HISTORIC AND DESIGN REVIEW COMMISSION

August 18, 2021

HDRC CASE NO: 2021-389
ADDRESS: 125 MAGNOLIA DR
LEGAL DESCRIPTION: NCB 6530 BLK 2 LOT 7
ZONING: R-4,H
CITY COUNCIL DIST.: 1
DISTRICT: River Road Historic District
APPLICANT: Sheryle Leal/Precision Contracting
OWNER: OLGUIN HANNAH
TYPE OF WORK: Window replacement, construction of a front porch, exterior modifications, site modifications, roof replacement
APPLICATION RECEIVED: July 26, 2021
60-DAY REVIEW: Not applicable due to City Council Emergency Orders
CASE MANAGER: Stephanie Phillips

REQUEST:

ELEVATIONS

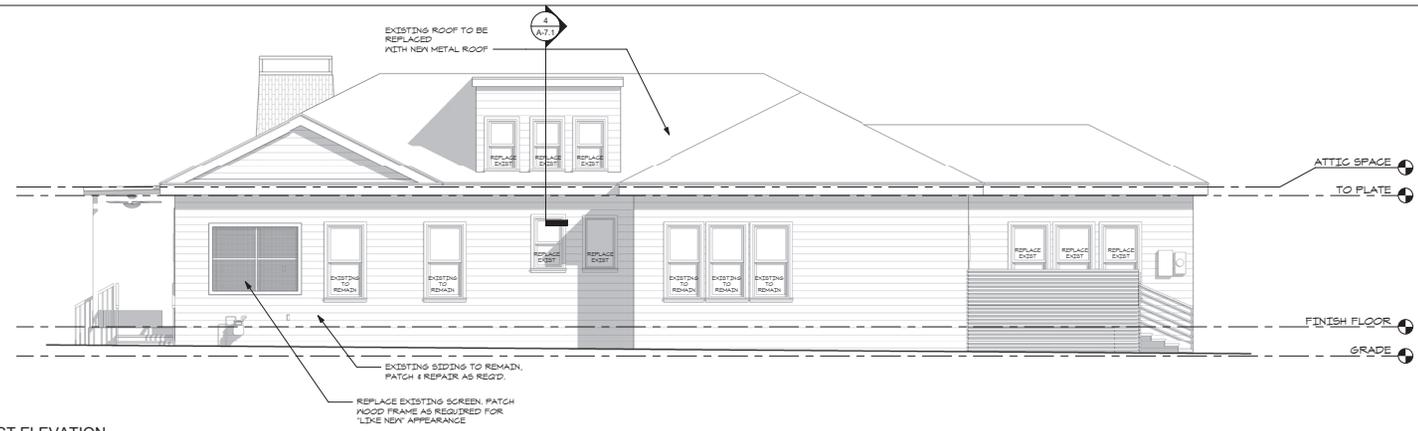
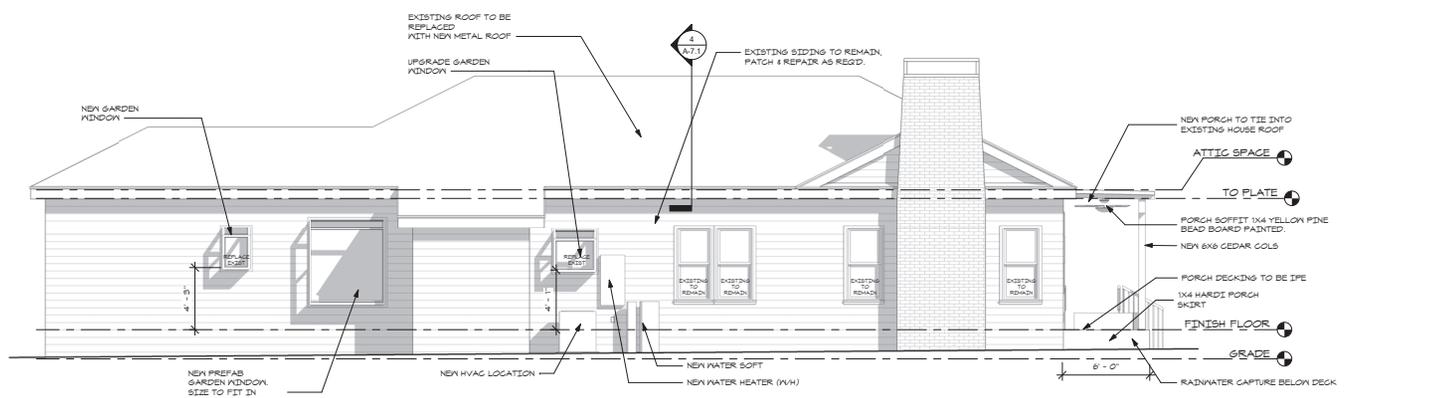
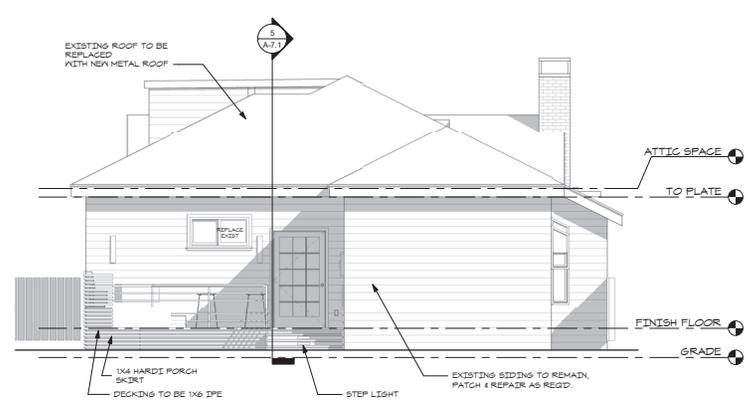
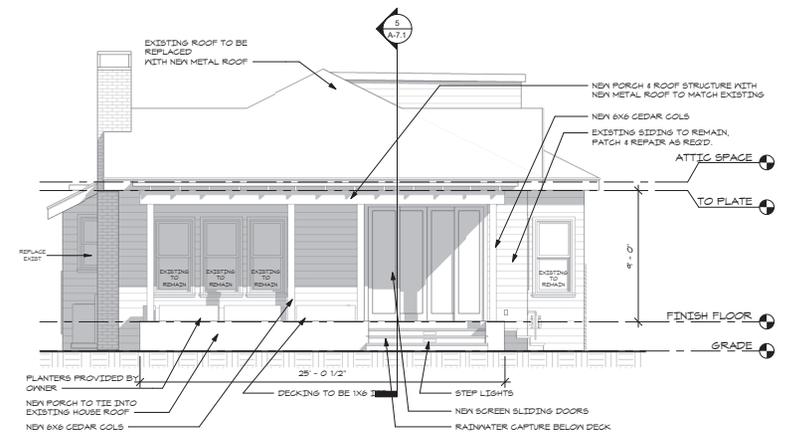
- e. **FRONT ENTRYWAY CONFIGURATION MODIFICATIONS** – The applicant has proposed to modify the existing front door and entryway configuration. The current configuration features a screen door centered between two full-height window screens with a mullion and muntin pattern that echoes the proportion of the existing historic windows on the house. The door and window screens fill the opening of the original front porch as evidenced on the 1911-1951 Sanborn Map. Based on the submitted elevations, the applicant has proposed to replace this configuration with two sliding glass doors and infill the remaining wall with siding. Per the Historic Design Guidelines, alterations to porches should result in a space that functions, and is visually interpreted as, a porch. Use the exterior muntin pattern, profile, and size appropriate for the historic building when replacement windows or screens are necessary. Staff finds that the existing porch configuration visually reads as an enclosed front porch, which helps clearly tell the story of the evolution of the home. Staff finds that the removal of this configuration and enclosure with sliding glass doors eliminates this condition. Staff finds that the existing screened porch configuration should be retained. Outfitting the existing screens and door with glass, or installing fixed panes clad with a similar mullion and muntin pattern, is eligible for administrative approval.

- f. **NEW FRONT PORCH** – The applicant has proposed to install a front porch with a low-sloping shed roof with rafter tails. The porch will measure approximately 25 feet in length, just shy of the width of the front façade, and will extend 9 feet in depth towards the street. Per the setback diagram submitted by the applicant of the property, a 10’ setback will remain from the street. According to Guideline 7.A.i, new porches should not be added where historically present and new front porch elements should be simple as to not distract from the historic character of the building. Details should not convey a false sense of historic appearance. Per Sanborn Maps, there is evidence that a recessed porch existed historically on this property and was enclosed over time as noted in finding e. The current proposal requests to add a second porch where one did not historically exist. Additionally, based on the information provided, the front porch may have a setback that is more shallow than existing porches on surrounding properties. Staff does not find the proposal consistent with the Guidelines.

Item 3, Staff does not recommend approval of the front entryway modifications as proposed based on finding e. Staff finds that this existing configuration should be retained. Outfitting the existing screens with glass, or installing fixed panes clad with a similar mullion and muntin pattern, is eligible for administrative approval.

Item 4, Staff does not recommend approval of the construction of a new front porch based on finding f. If the HDRC finds that a new front porch is appropriate, staff recommends the following stipulations:

- i. That the porch elements comply with the following stipulations: RAILING - The proposed railings (on the steps) should feature both a top and bottom rail. The bottom rail should feature a vertical orientation and should be installed approximately three to four inches above the porch decking. Both top and bottom rails should be constructed from 2"x4" members. The proposed railing should not feature an overall height of more than three (3) feet. COLUMNS - The proposed wood columns should be no wider than 6' square, feature both capital and base trim and chamfered corners. DECKING - The proposed porch decking should feature 1" x 3" tongue-and-groove wood members laid perpendicular to the front façade plane.

- ii. That the applicant submits a setback diagram study that includes the two immediate adjacent properties to illustrate the proposed front porch setback relative to the existing neighbors. The depth of the new front porch must not exceed the depth of the neighboring properties. If the proposed 9' depth creates a setback that is closer to the street than the immediate neighbors, the depth must be reduced and updated drawings must be submitted. This diagram is required to be submitted to staff for review and approval prior to the issuance of a Certificate of Appropriateness.

① FLOOR PLAN
1/8" = 1'-0"

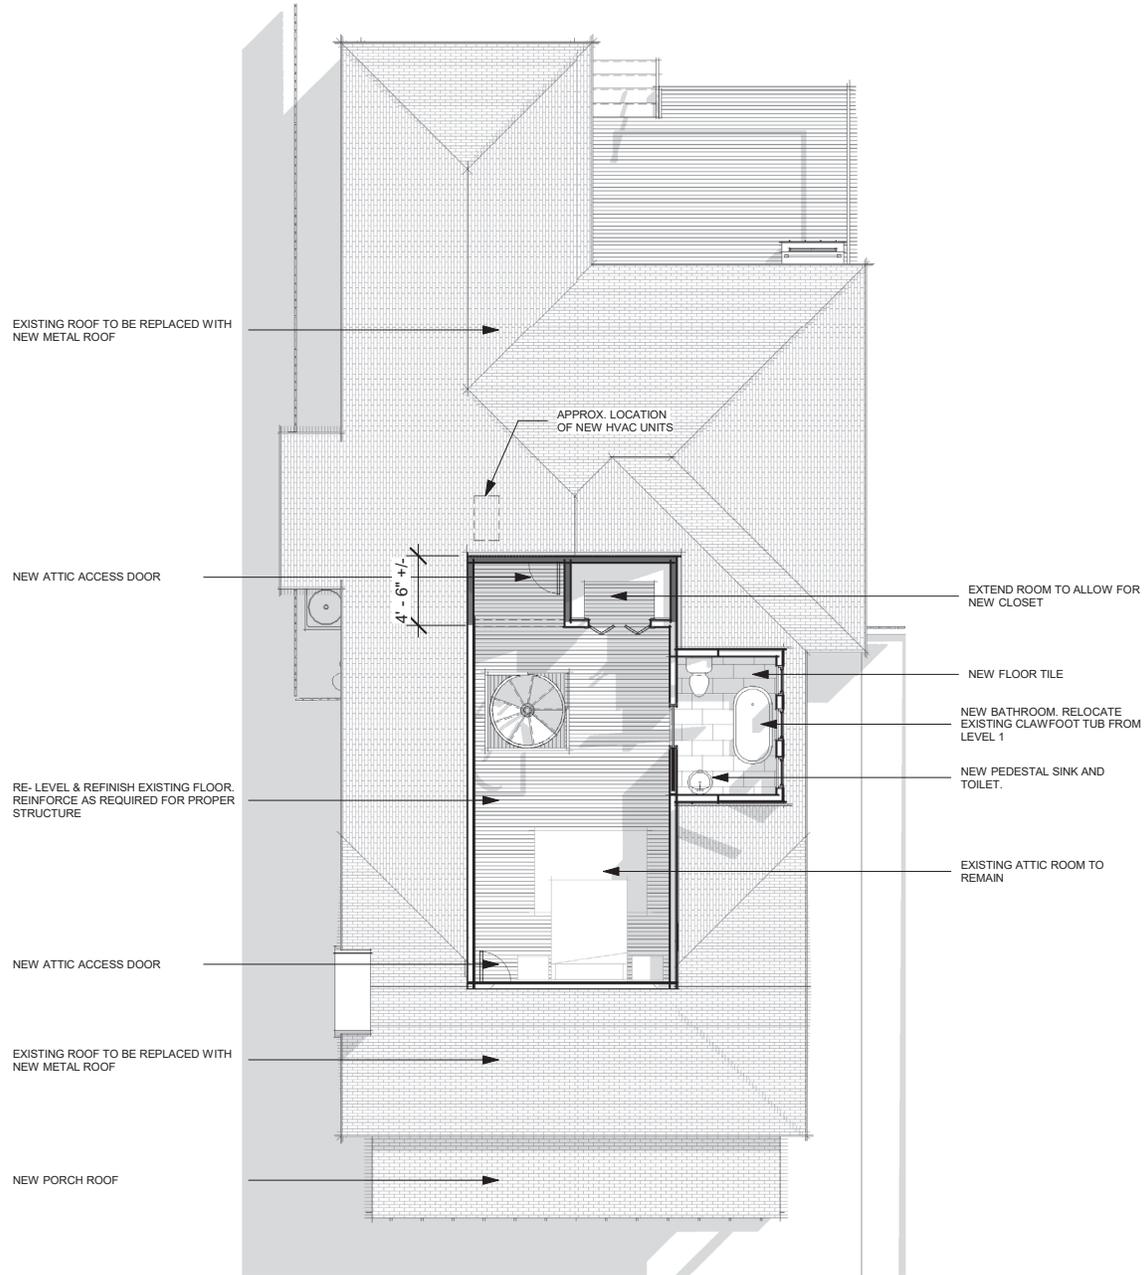
- g. **RIBBON DRIVEWAY** – The applicant has proposed to install a ribbon driveway to replace the existing concrete driveway. Staff finds the request appropriate with the stipulations listed in the recommendation.

Item 5, Staff recommends approval of the installation of a ribbon driveway with the stipulation that the total width of the driveway not exceed 10 feet and the concrete approach flare to a maximum width of 12 feet.
